# Appendix A

LB Camden comments

**From:** Dewes, Tatai <Tatai.Dewes@camden.gov.uk>  
**Sent:** 05 November 2019 12:21  
**To:** Alex Neal <ANeal@geraldeve.com>; Henry, Kate <Kate.Henry@camden.gov.uk>  
**Cc:** Sam Avis <SAvis@geraldeve.com>  
**Subject:** SPCC - transport comments

<b>To:</b>	Kate Henry
<b>From:</b>	Tatai Dewes
<b>Date:</b>	7 <sup>th</sup> November 2019
<b>Re:</b>	St Pancras Commercial Centre 63 Pratt Street London NW1 0BY
<b>Proposal:</b>	Demolition of existing buildings (Class B1c/B8); erection of 3x buildings ranging in height from 5 to 7 storeys above ground and a single basement level comprising a mixed use development of light industrial floorspace (Class B1c/B8), office floorspace (Class B1), 33x self-contained dwellings (Class C3), flexible retail floorspace (Class A1/A3); associated access and servicing, public realm, landscaping, vehicular and cycle parking, bin storage and other ancillary and associated works
<b>Reference:</b>	2019/4201/P
<b>Key points:</b>	Recommended for approval subject to

SKETCH - Basement Market Plan Cycle Store

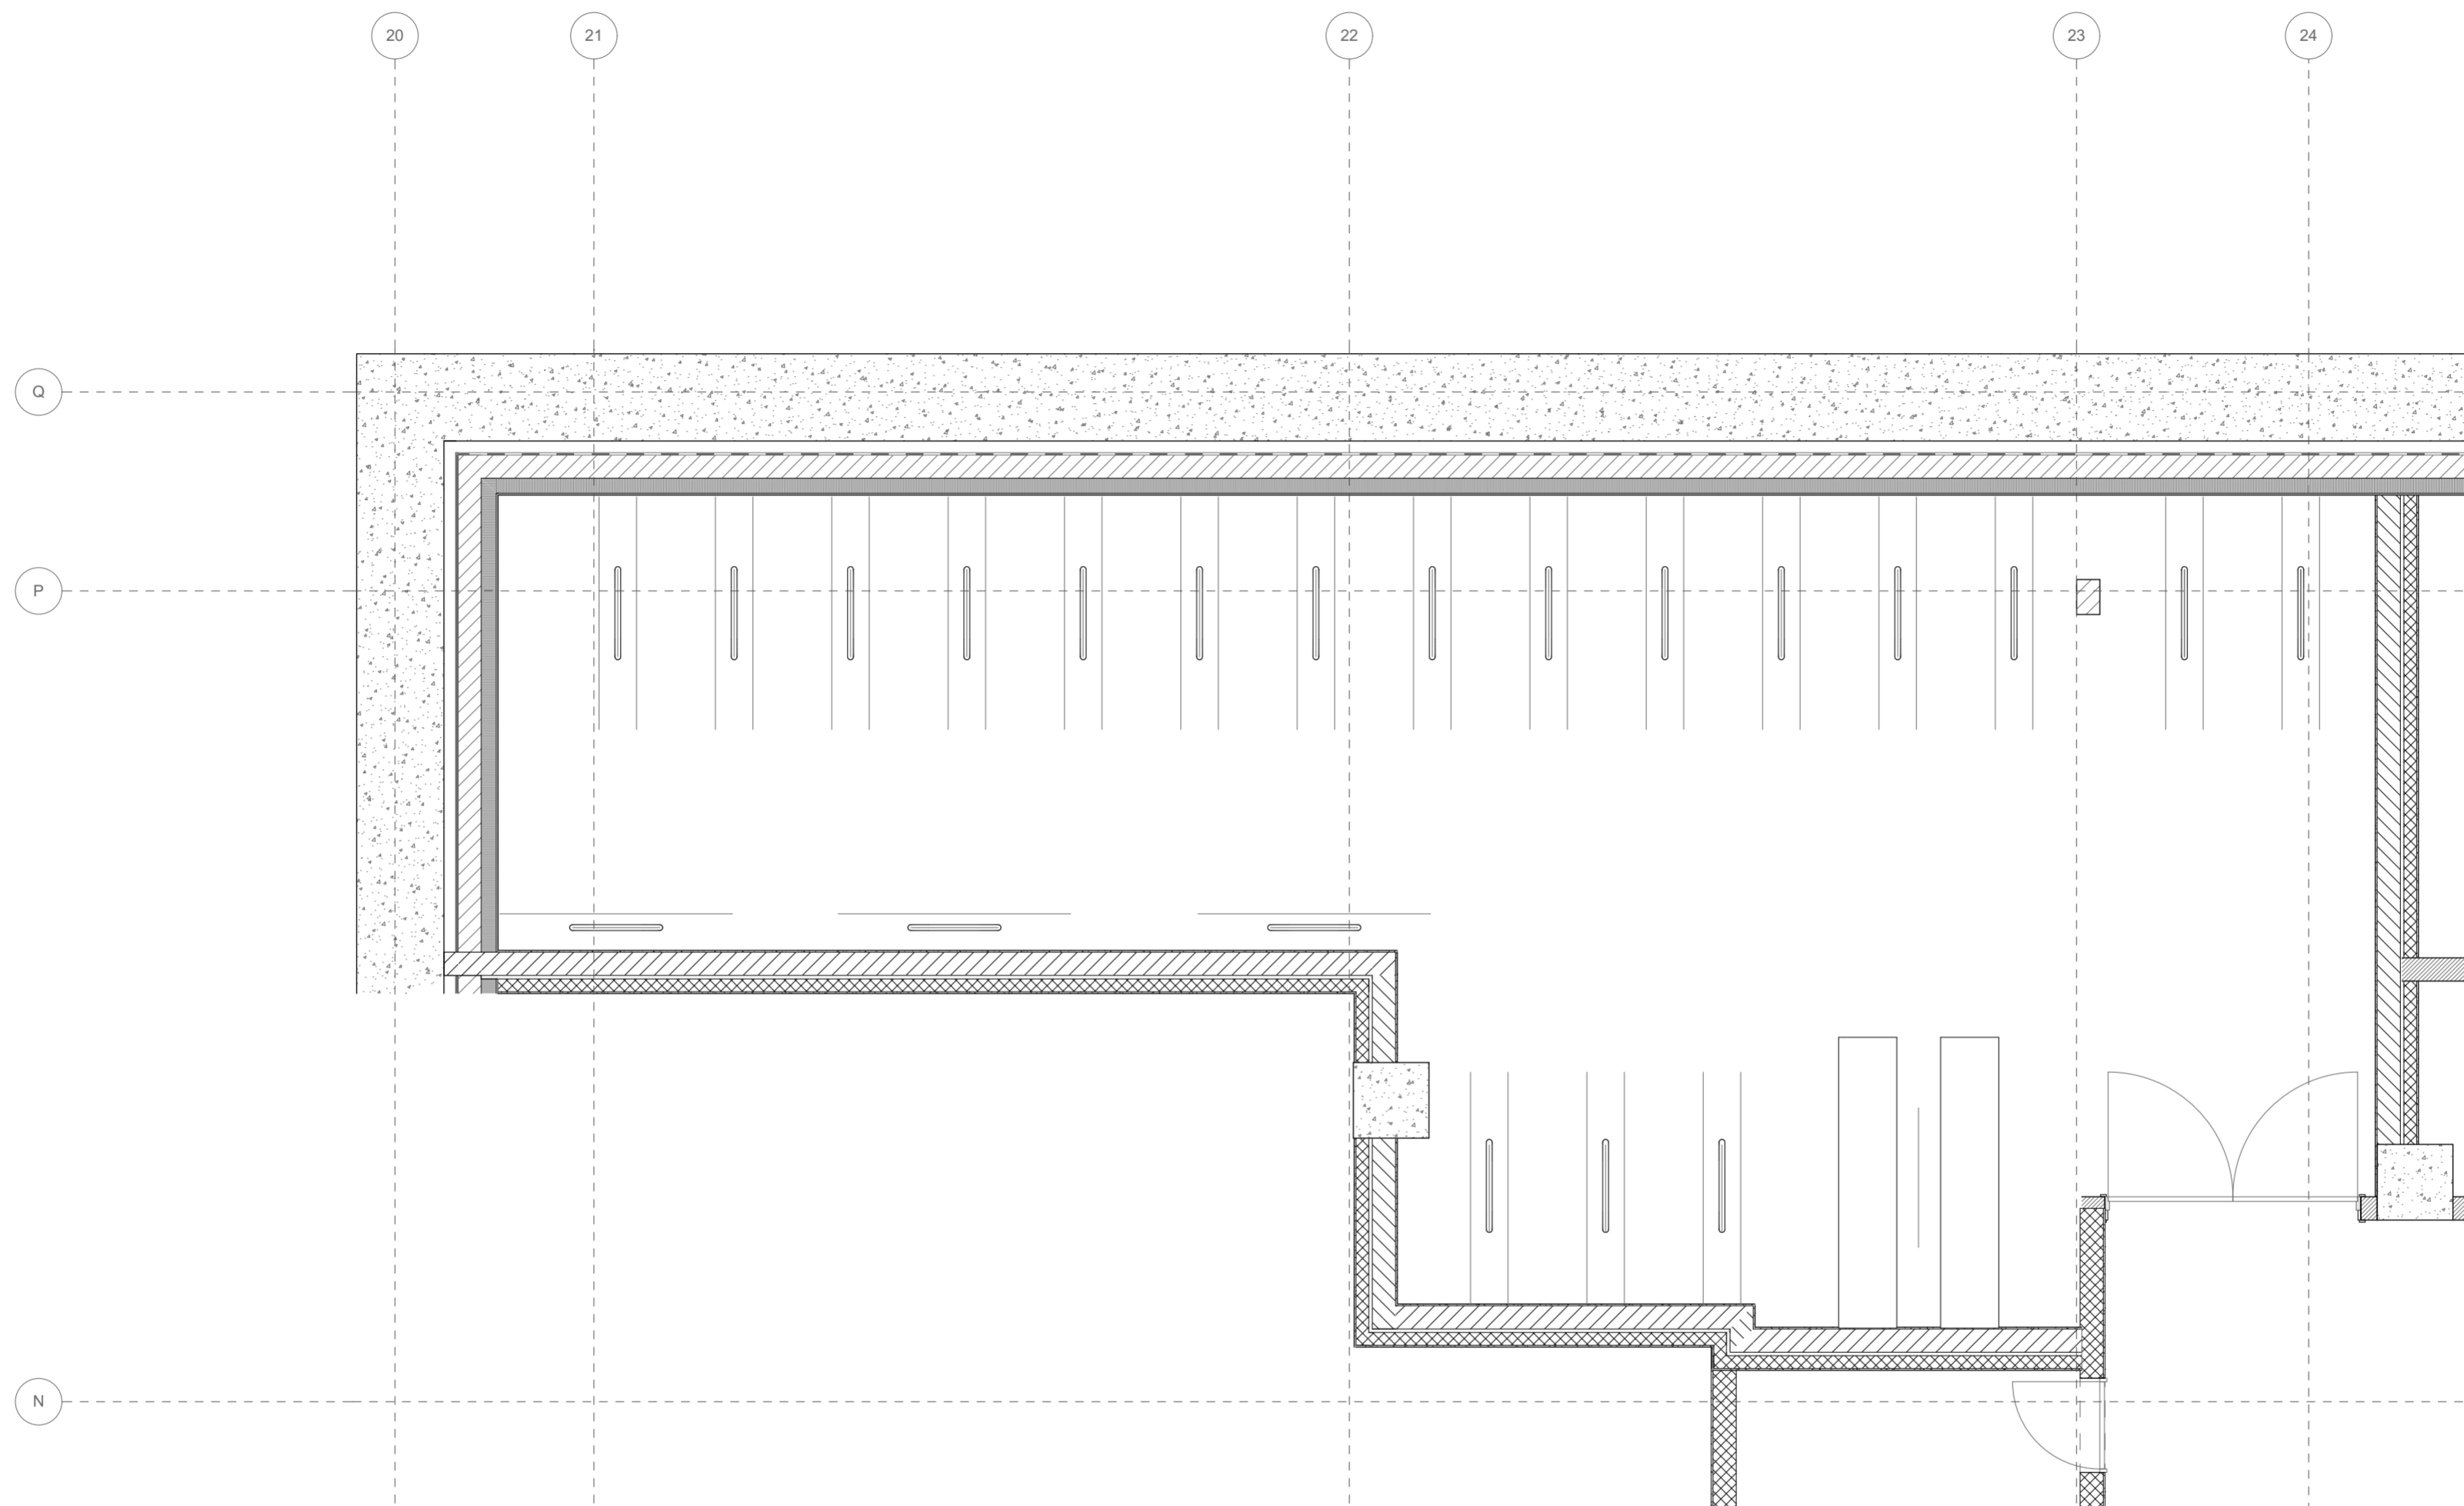
1. Further information and detailed plans are required for the cycle parking, detailed below:
  - a. The level of provision proposed does not meet the minimum requirement of the draft London Plan for residential and retail uses. The proposed provision falls two short of the residential requirement (currently at 59). The shortfall in residential spaces may be due to the revised plans increasing the number of residential units from 32 to 33. The extra spaces need to be accommodated, as are the retail spaces.

- b. There are no retail spaces provided. These need to be provided and detailed in the plans.
  - c. The council also expects that there is a provision for non-standard cycles. The Transport Assessment confirms that 5% of spaces in the office cycle store will be configured to accommodate non-standard cycle designs including those for users with mobility impairments. These spaces should be outlined in the detailed plans.

- d. The 15 spaces required as part of the Light Industrial use are proposed to be either located in with the B1 office cycle store or within the Light Industrial units themselves. The cycle provision for the different uses needs to be separate, as these uses/buildings will be under separate use and management. The location of the spaces needs to be shown on the plans.

- e. More information is required on the type of stands and the detailed design/layout of the cycle parking stores to assess if the design meets the requirements set out in CPG Transport and TfL's cycle parking guidance (LCDS). These plans need to be to scale, and include the distance between each stand, the widths of isles between stands and between stands and walls. The dimensions of the lifts (door and lift width, length) should also be given or shown on the plans.
